Technical Bulletin

Model: MET-C2yz	Date: 13-May-16	No.: RD244001i
-----------------	-----------------	----------------

Subject: Firmware Release Note: System/Copy		Prepared by: M. Kumagai	
Classification:	<input type="checkbox"/> Troubleshooting <input type="checkbox"/> Mechanical <input type="checkbox"/> Paper path <input type="checkbox"/> Product Safety	<input type="checkbox"/> Part information <input type="checkbox"/> Electrical <input type="checkbox"/> Transmit/receive <input checked="" type="checkbox"/> Other (Firmware)	<input type="checkbox"/> Action required <input type="checkbox"/> Service manual revision <input type="checkbox"/> Retrofit information <input checked="" type="checkbox"/> Tier 2

CAUSE

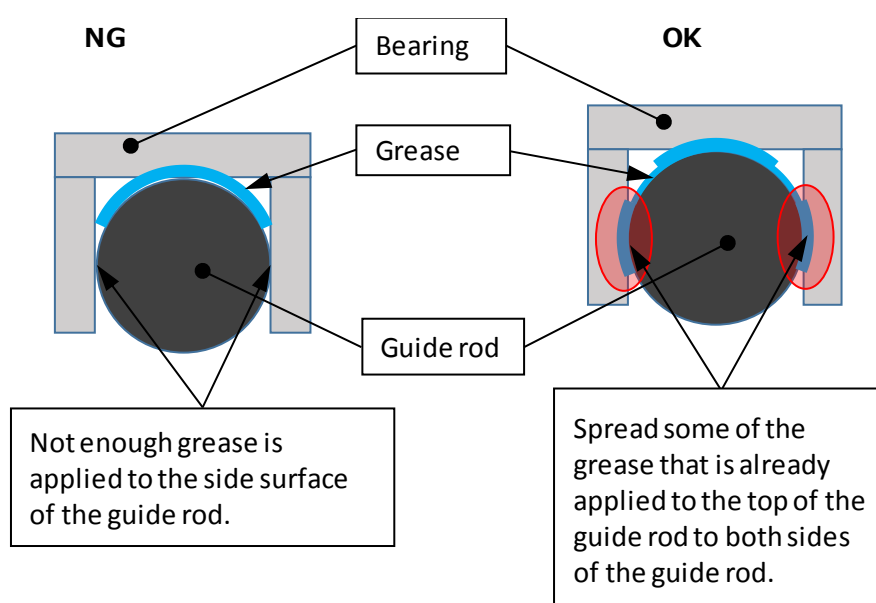
Not enough grease is applied to the side surface of the guide rod. As a result, there is friction between the scanner carriage and guide rod on both sides.

The grease application process was revised so that enough is applied to the side surfaces of the guide rod since 9 Oct 2017.

Fig.1

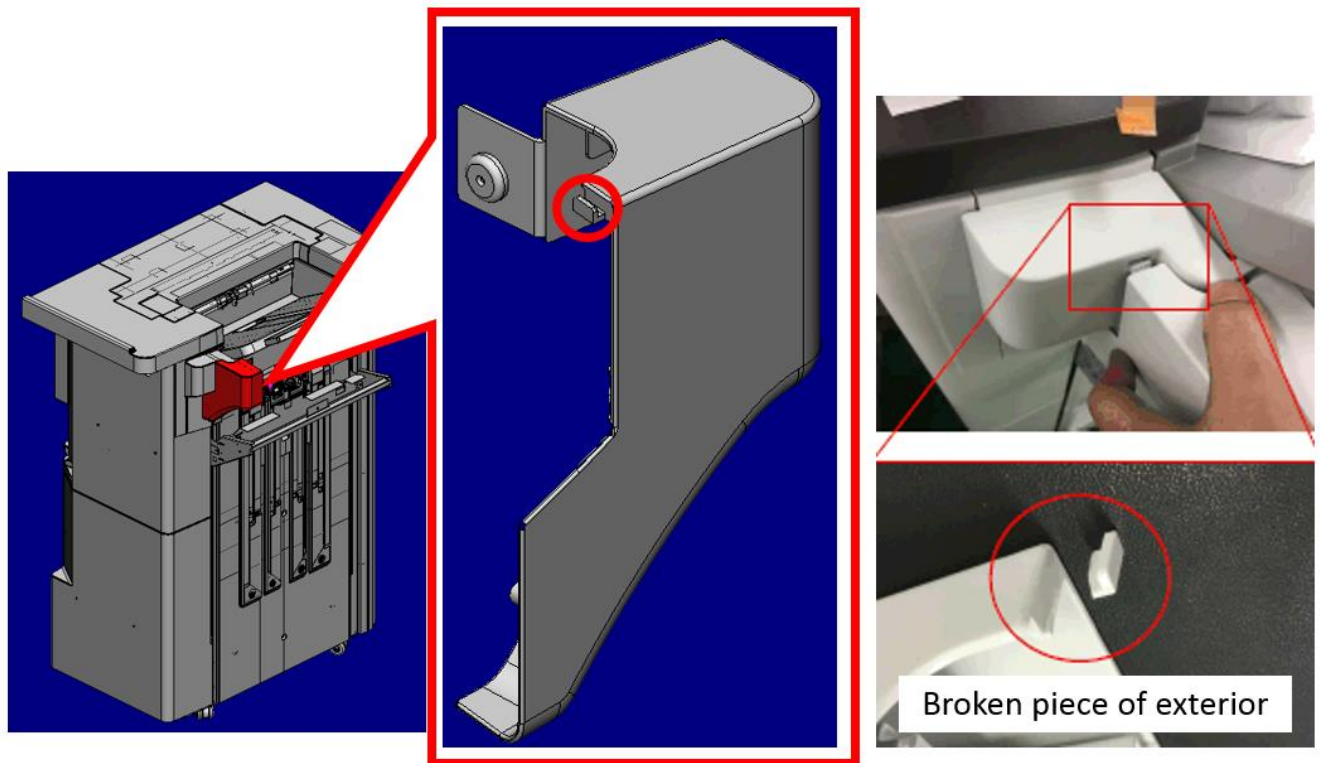
This prevents the paper guide from returning to the home position.

d238z2176

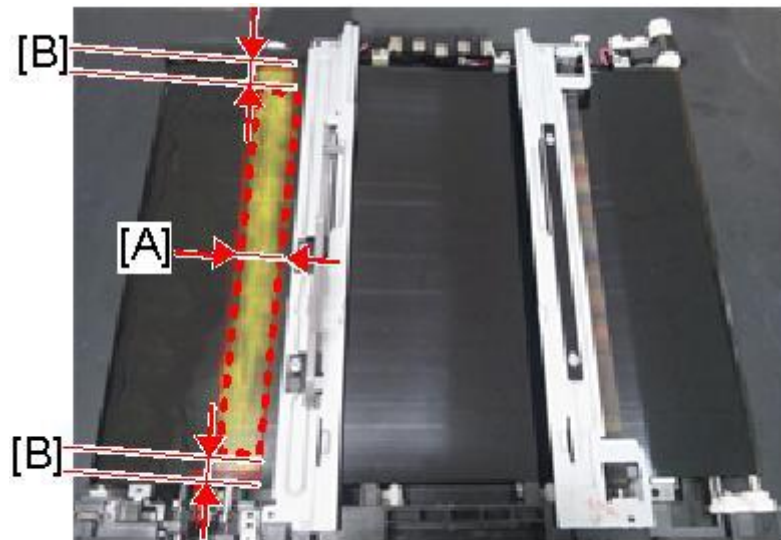
~~7 Attach the image transfer cleaning unit.~~

7 Put toner on the image transfer belt.

Service Manual Correction

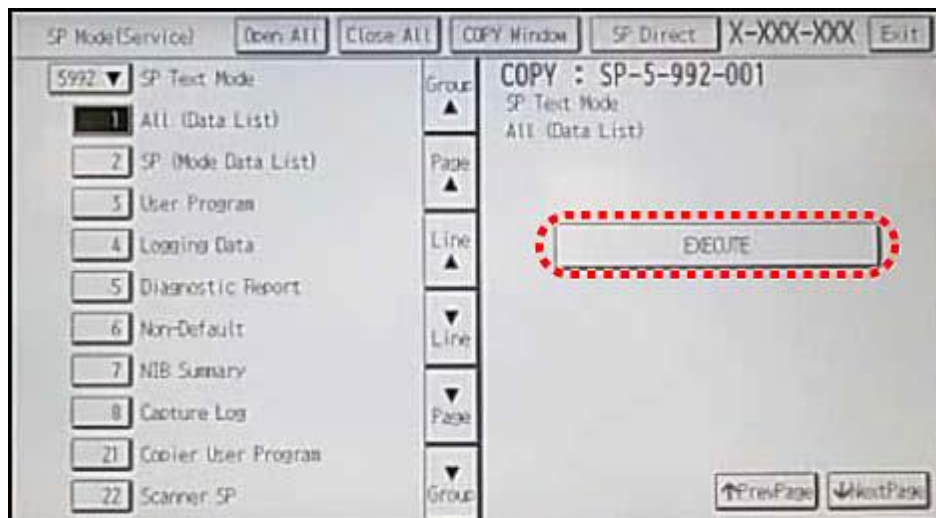
The two areas shown in **bold** were corrected.

Overview

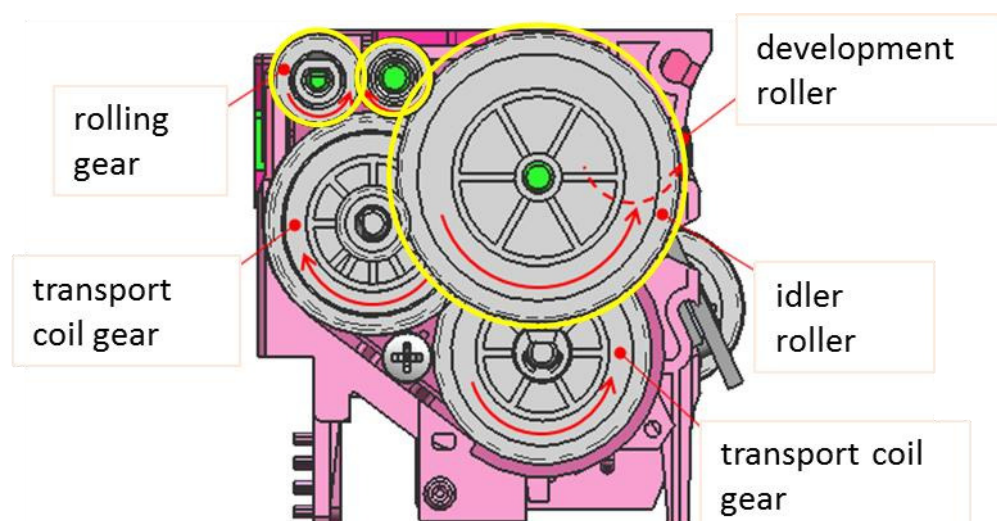
Three new gears (yellow circles) are added. They are driven from the developer collection coil gear, so the seal is automatically wound. This mechanism works at installation and/or replacement.

Figure.1

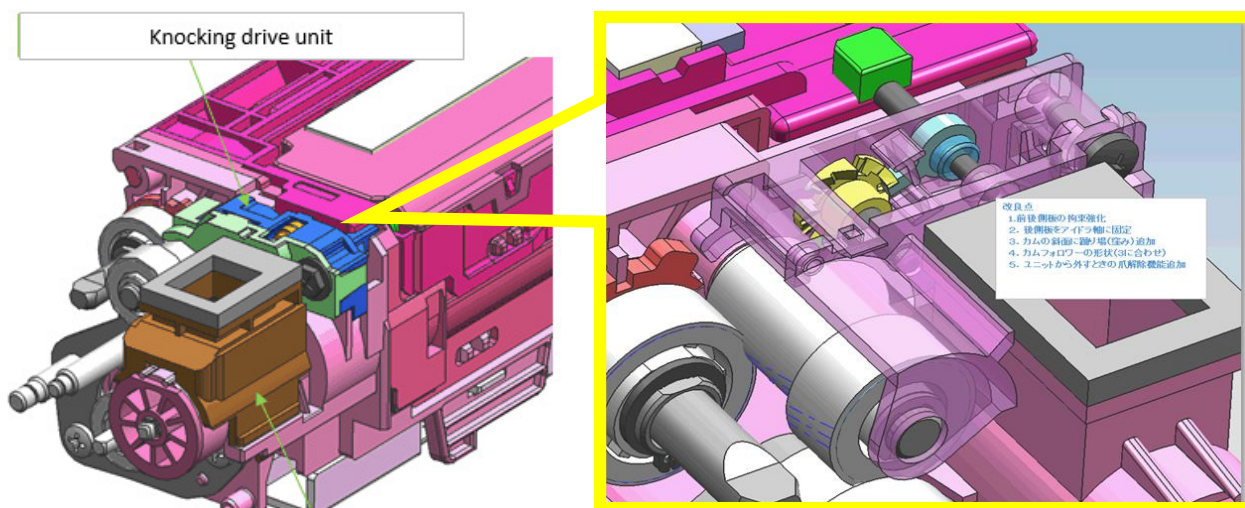
~~A new knocking mechanism has been added (Fig.1). Normally, the air flows from the development roller to the filter in the development unit (Fig. 2). However, when the filter is full of toner, the inner pressure increases and reverse air flow occurs, which causes toner blasting to occur (Fig.3). To prevent this, the knocking mechanism periodically knocks the development unit cover, so toner in the filter drops back into the development unit. This mechanism works by reverse rotation of the development roller.~~

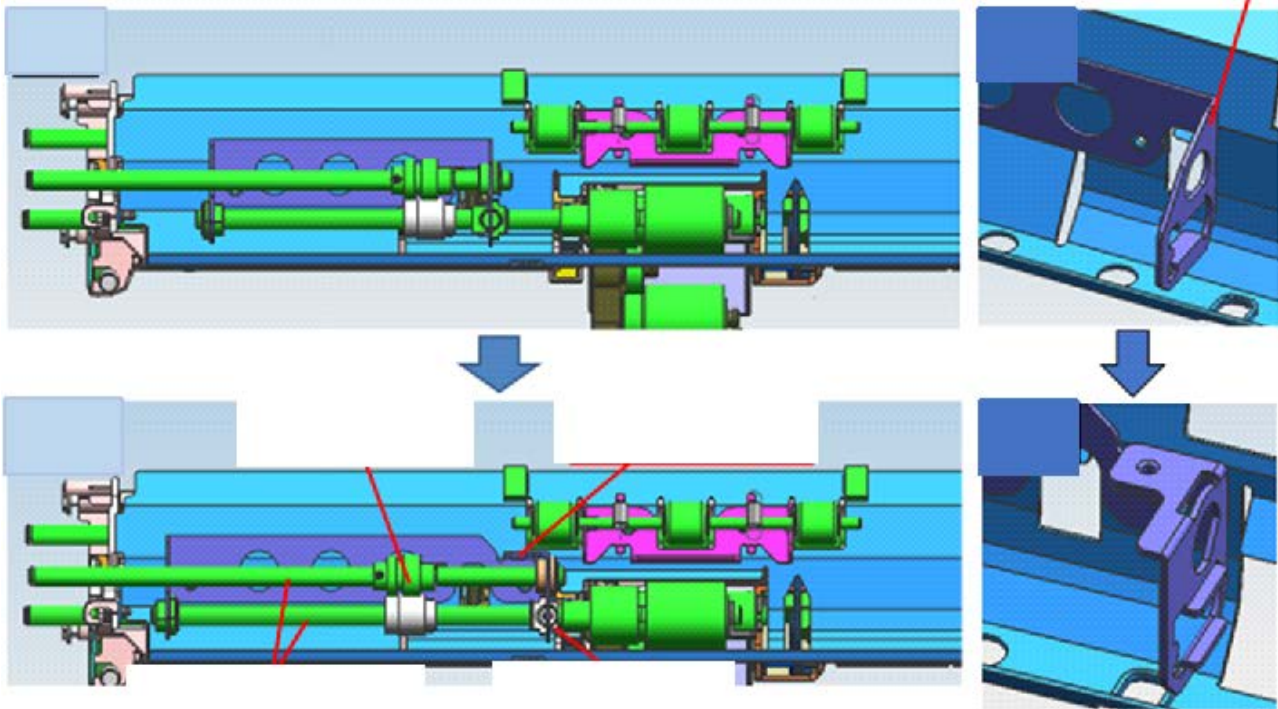
Change 4: There are no protruding parts to hold the gear. An e-ring added to stop the gear in position, and a groove added to the shaft for the e-ring.

Old P/N <Group B>	New P/N	Description	Int	Q'ty	Note
07200040E	07200040E	RETAINING RING - M4	-	3->4	D
D2414631	D0BQ4631	SIDE PLATE:REAR:DUPLEX:PEEN	X/X	1	D
D2414644	D0BQ4644	GEAR:MECHANICAL ROLLER CLUTCH	X/X	1	D

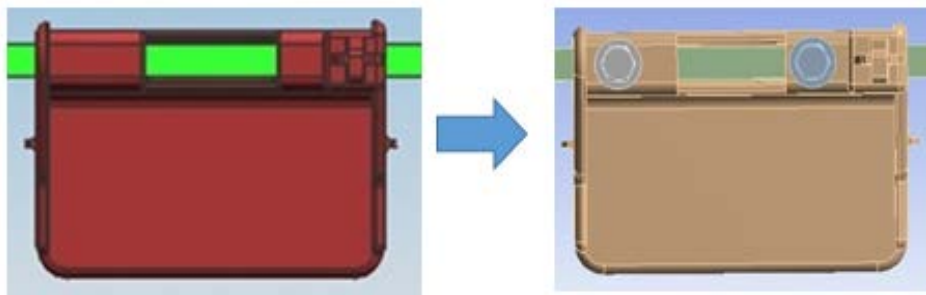
Old P/N <Group A/B/D>	New P/N	Description	Int	Q'ty	Note
-	03603006N	SCREW - M3X6	-	0->2	E
D1754654	D0BQ4654	SHAFT:LEVER:LOCK	X/X	1	E
D1494655	D2894655	GRIP:DUPLEX UNIT	X/X	1	E
